**SUBJECT: REVIEW OF TRANSPORTATION IMPACT STUDY – THE VIEWS
SUBDIVISION**

**RE: CITY OF SANDY
THE VIEWS PUD (FILE NO. 20-028 SUB/TREE/FSH/PD)
PRELIMINARY REVIEW**

Re: File 20-028 SUB/TREE/FSH/PD The Views PD (120-SFD and 48 MFD)

**SUBJECT: REVIEW OF ODOT RESPONSE AND TECHNICAL MEMORANDUM –
THE VIEWS SUBDIVISION**

Site Plan

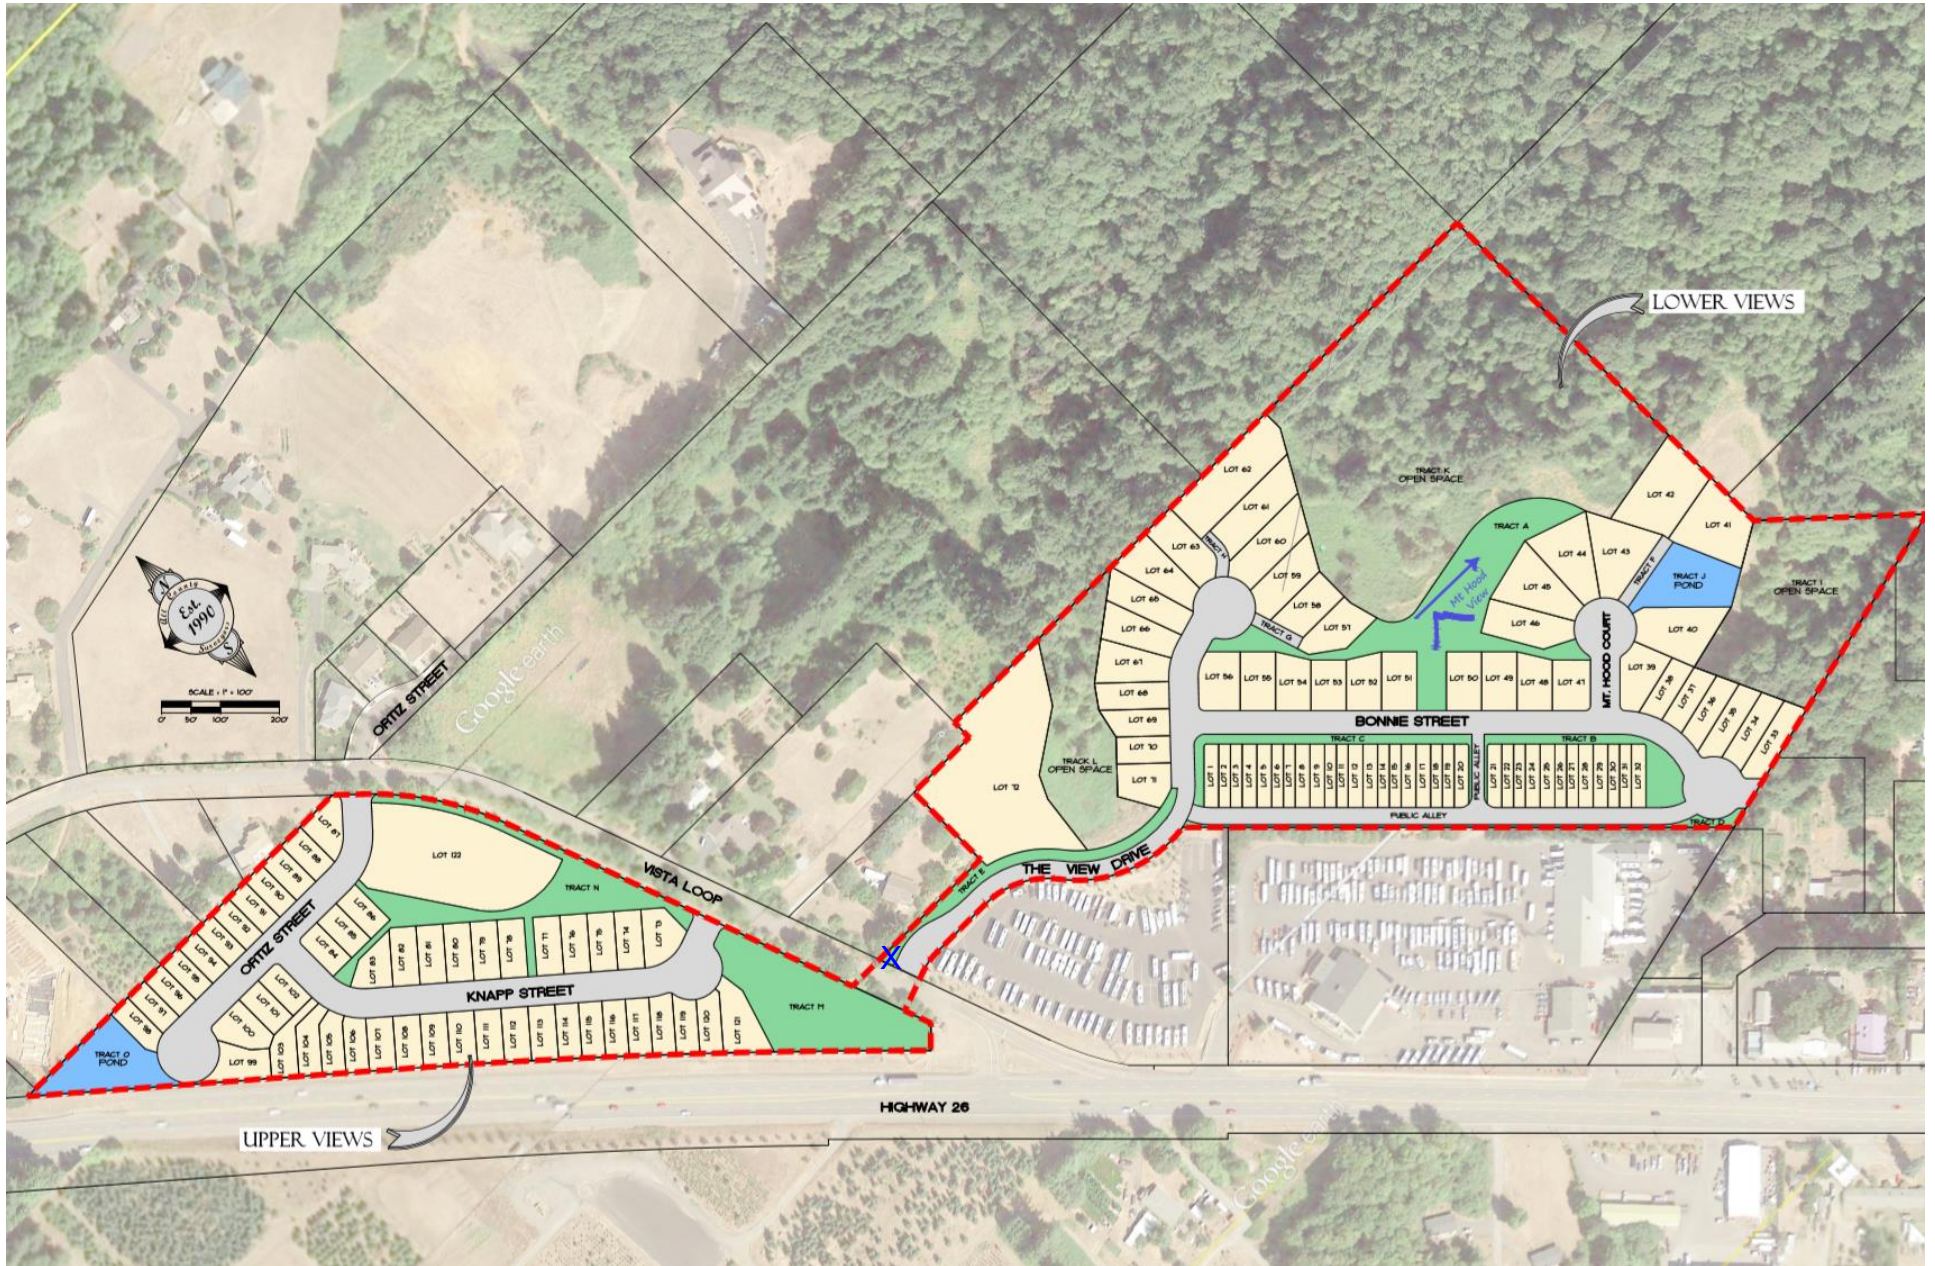
The proposed development will require a concrete bus shelter pad and a green bench (Fairweather model PL-3, powder-coated RAL6028). The required pad size is 7' x 9.5' and should be located at the entrance of the view Drive (see blue x for preferred location). Engineering specifications are available from the transit department.
